Metropolitan Planning Commission

Staff Reports

May 8, 2008

Subdivision 2008S-078U-05
Sharpe Avenue Divide
6 - Jameson
5 - Porter
Daniel Fell, owner, Delle Land Surveying, surveyor

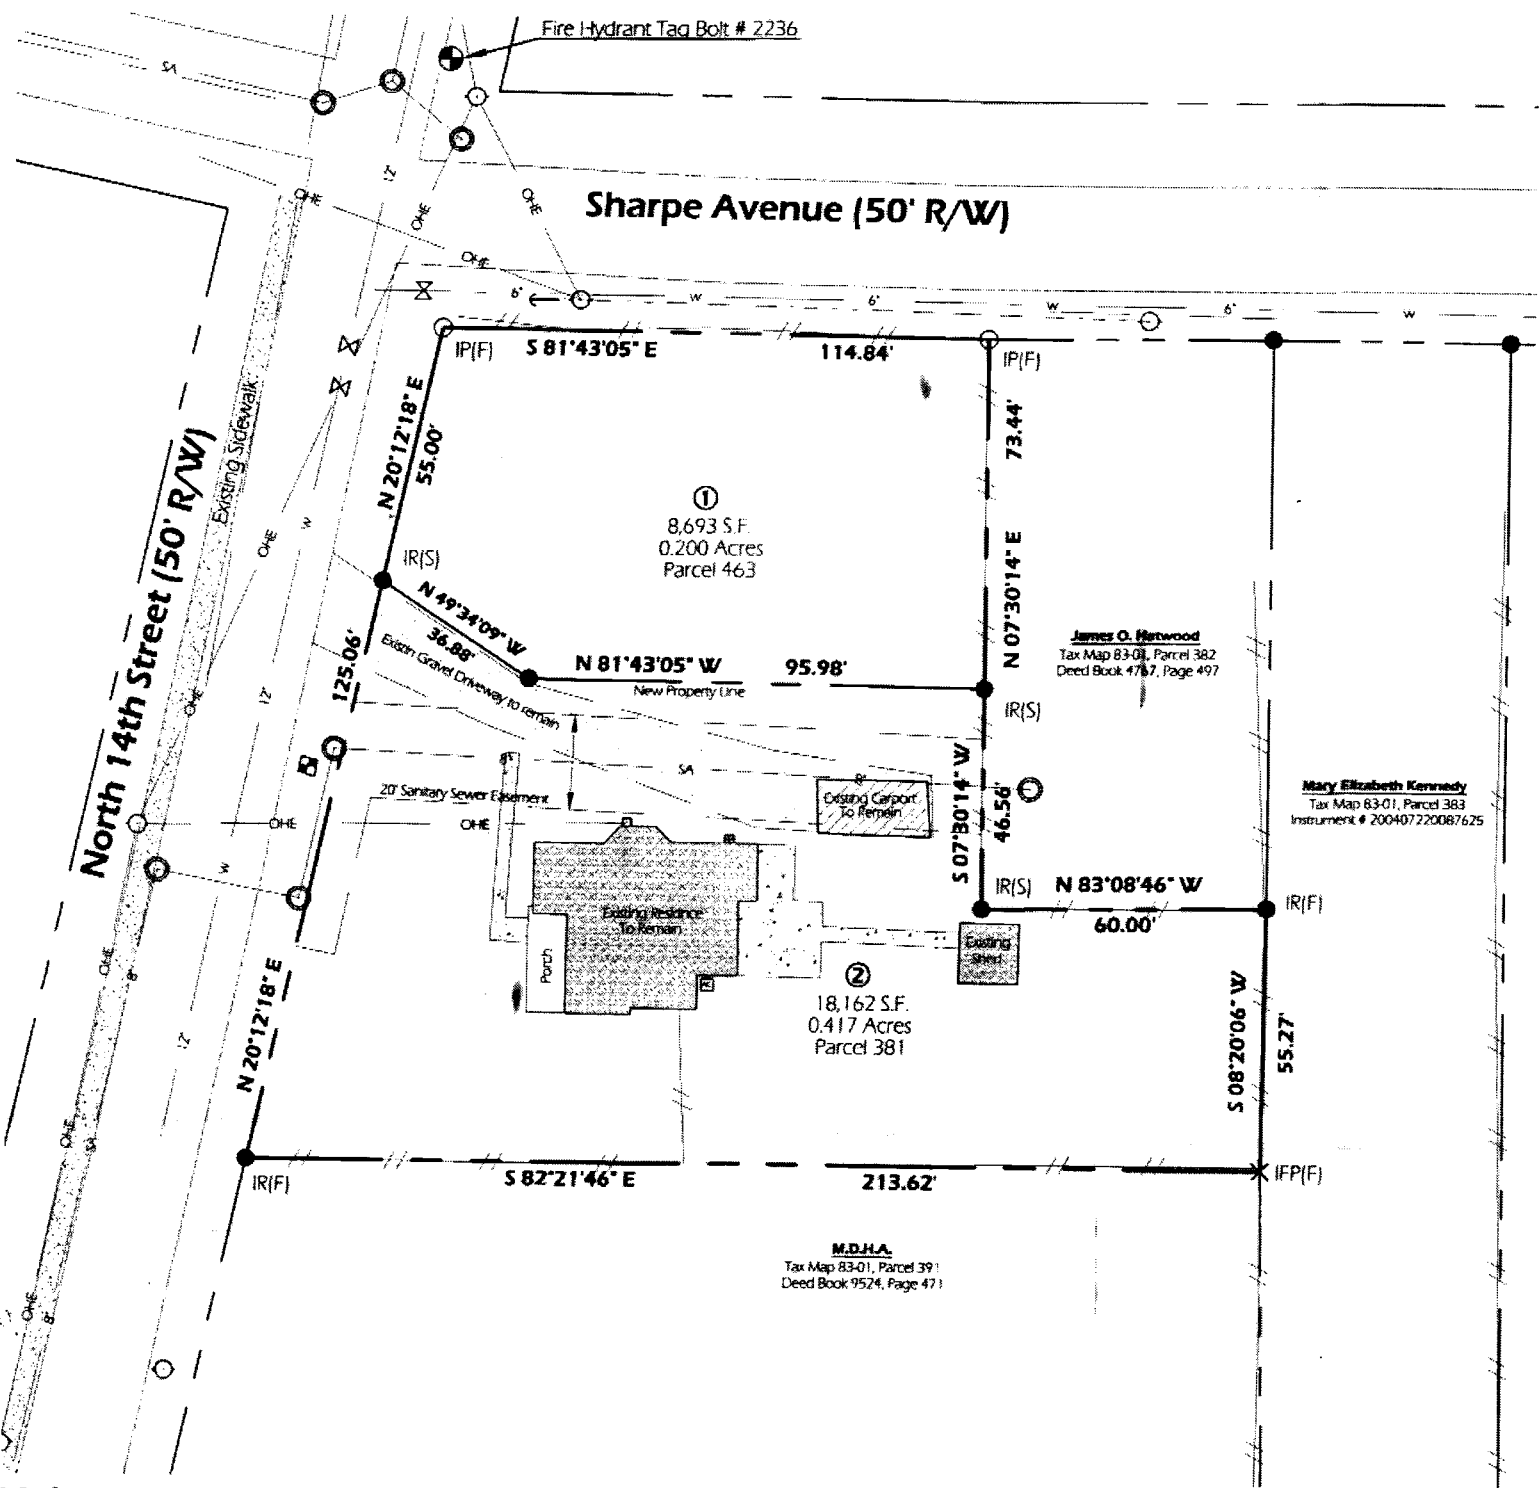
Section 3-8.2b of the Subdivision Regulations states a new sidewalk shall be constructed on street(s) fronting the property wherever a public sidewalk already exists on the same block face. The applicant is requesting a variance to this section of the regulations stating that a substantial amount of grading on the lot, including raising a manhole, and water meter create a hardship. If the Planning Commission finds that extraordinary hardships or practical difficulties may result from strict compliance with the Subdivision Regulations, a variance from the regulations may be granted.

The Subdivision Regulations state that the creation of a new or additional development right requires the construction of a sidewalk where a lot fronts a public street. A sidewalk must be constructed on either Lot 1 or Lot 2. A constructability analysis was performed by the Public Works Department to assess the physical and

topographic conditions of the site for sidewalk construction. The analysis found that sidewalks can be constructed to match the Public Works Department standard drawing number ST-210. As such, no particular hardship would be incurred by the applicant since there are no physical, topographic or unique conditions on the site that preclude compliance with the sidewalk requirement.

As proposed, the creation of Lot 1 would result in a non-radial lot line on the northwest property line between Lot 1 and Lot 2 to accommodate the configuration of the existing driveway.

Lot 1 does not meet the minimum requirement for lot frontage on North 14th Street.

Construct sidewalk to match the Department of Public Works standard drawing number ST-210. With sidewalk construction, begin gutter along the existing edge of pavement, with a minimum twenty (20') feet pavement width. Construct a curb ramp with detectable warnings at the intersection of Sharpe Avenue and North 14th Street. Grade 3:1 maximum slope from the back of the proposed sidewalk.

The grass furnishing area may be reduced (2' minimum) to accommodate sidewalk construction within the public right of way.

With the construction of curb & gutter for sidewalk construction, route storm water to the existing storm system located at proposed lot 2. A drainage structure may be required.

Staff recommends approval of the final plat to create two lots, but disapproval of the requested sidewalk variance. Also, staff recommends approval of a variance to allow the requested radial lot line and an exception to lot comparability. The non-radial lot line between Lot 1 and Lot 2 allows the driveway to remain on Lot 2, with minimal changes the configuration of the existing lot. The lots also meet two of the qualifying criteria to grant an exception to lot comparability. The property is within the Neighborhood General policy and within a one-quarter mile radius of an area designated as Mixed Use.

1. Prior to recordation, sidewalks shall be shown on the final plat.
2. Final plat is to be recorded within 180 days from this meeting date, unless deferred.

Harpeth Park, Lot 77, Setback Amendment

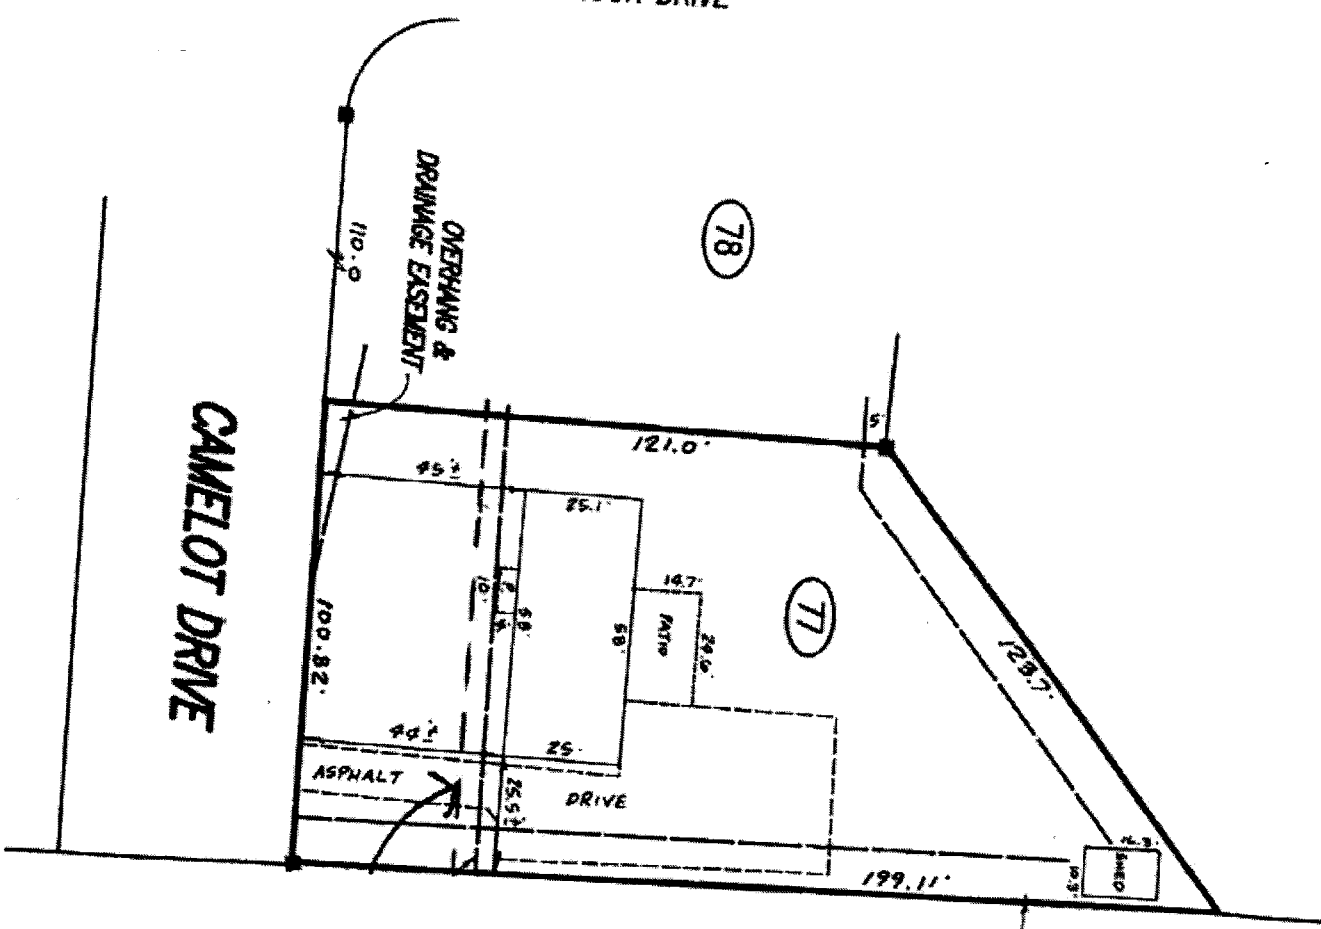
The property is located within the Harpeth Park subdivision. The applicant has requested that the platted front setback be amended from 40 feet to 35 feet in order to allow for the addition of a porch. This request is consistent with the average front setback along Camelot Drive of 35 feet.

The request is also consistent with section 17.12.030 C.(3) of the Metro Zoning Code. This section provides that the minimum required street setbacks for Single-Family Residential districts be the average of the street setbacks of the lots immediately adjacent on either side of the lot, in this case 35 feet, or the value provided in Table 17.12.030A, in this case 30 feet, or whichever is greater.

Staff recommends approval of the front setback amendment.
